BROADWATER

LOTS 1-3
 FIFTH ELECTION DISTRICT
 HOWARD COUNTY, MARYLAND
 TAX MAP 28 PARCEL 69

TYPICAL STREAM CROSSING FOR
BROADWATER LOT 2

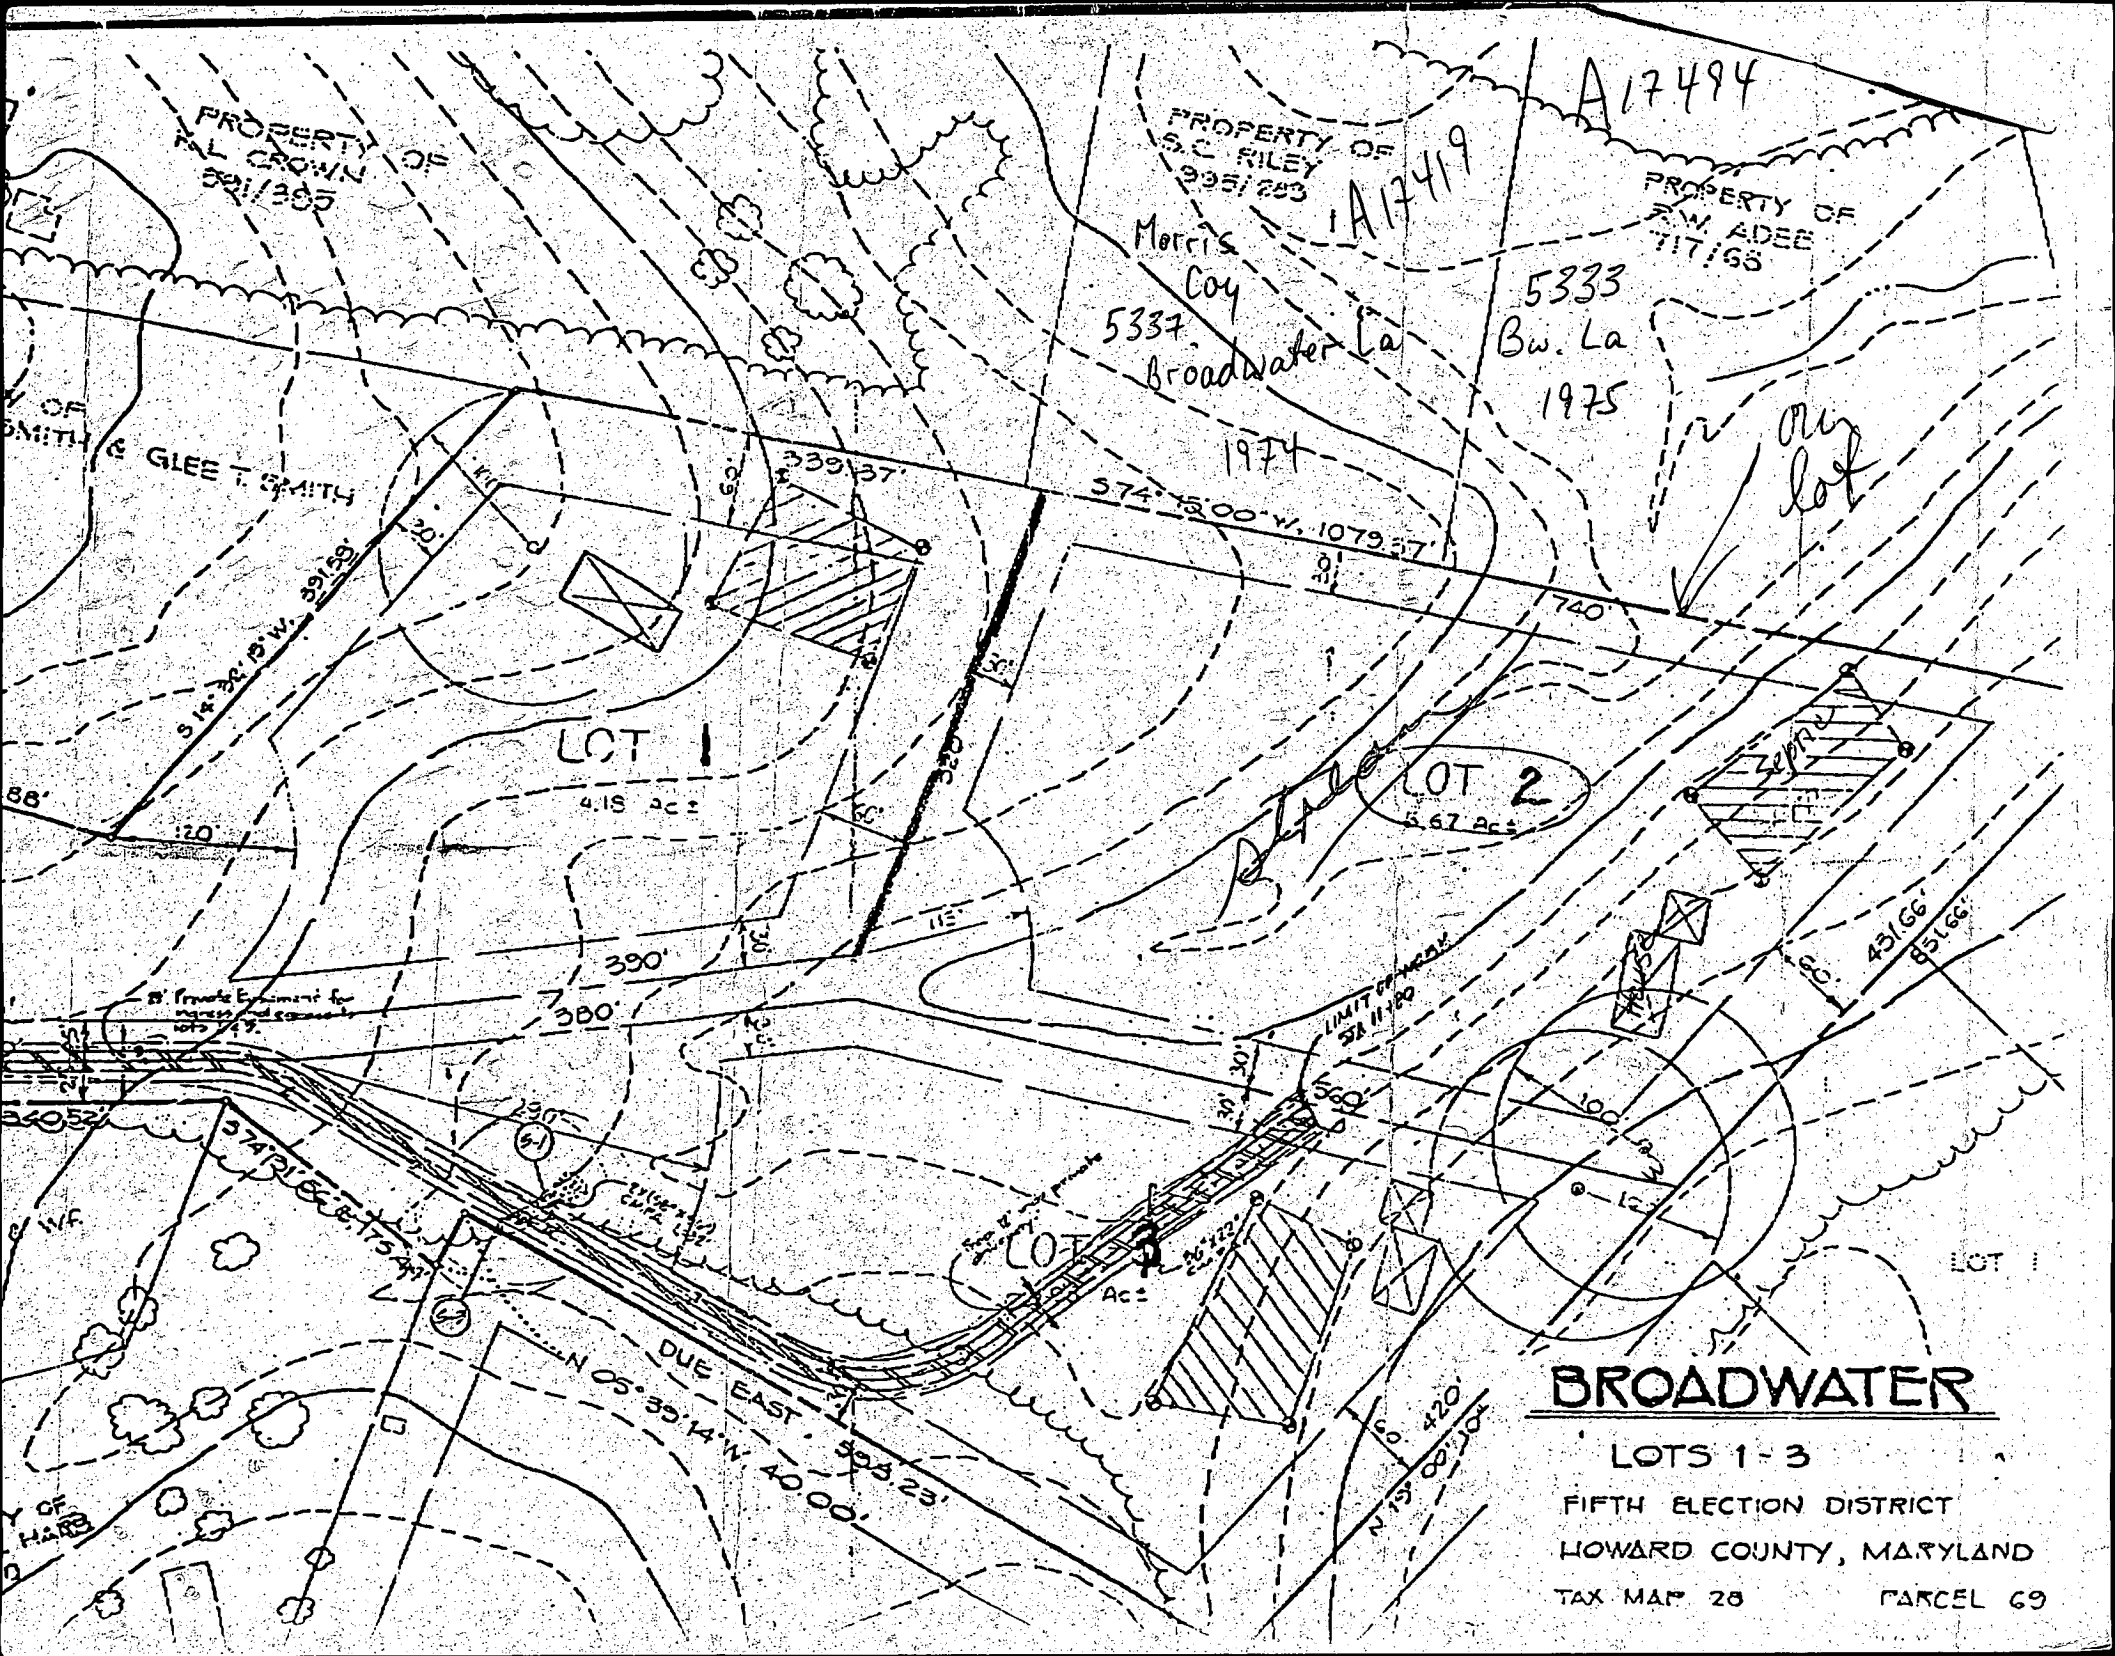
BP PLAN OK
 per CW 2/28/94

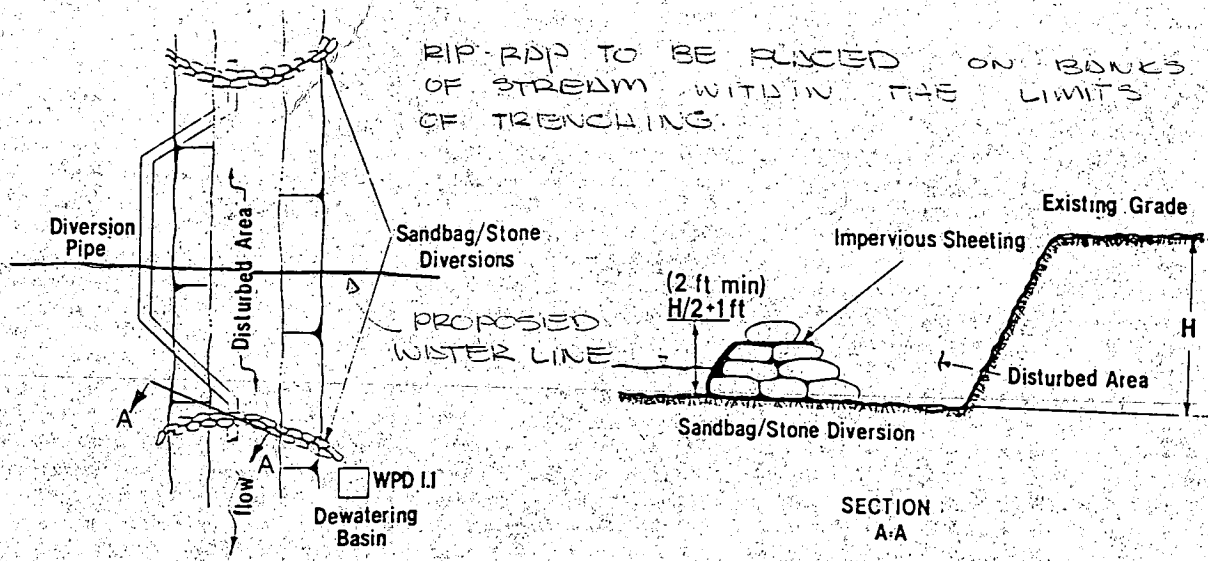
Wants to change perc area
to other side of stream on lot 2. Broadwater
sub-division. Has it ever been perced
on other side? Can it be perced? How
long can this take?

Called Mr. Kitchens.

Discussed application, perc test fee (\$335.00) and site
plan, ^{needed to obtain} ~~with~~ a perc date within 6 weeks of application
submittal. Some indication of rock at lower edge of
existing SD Area. Could not predict soils info. across
stream. Explained that 100 ft was required from stream
to septic easement. JENadeau
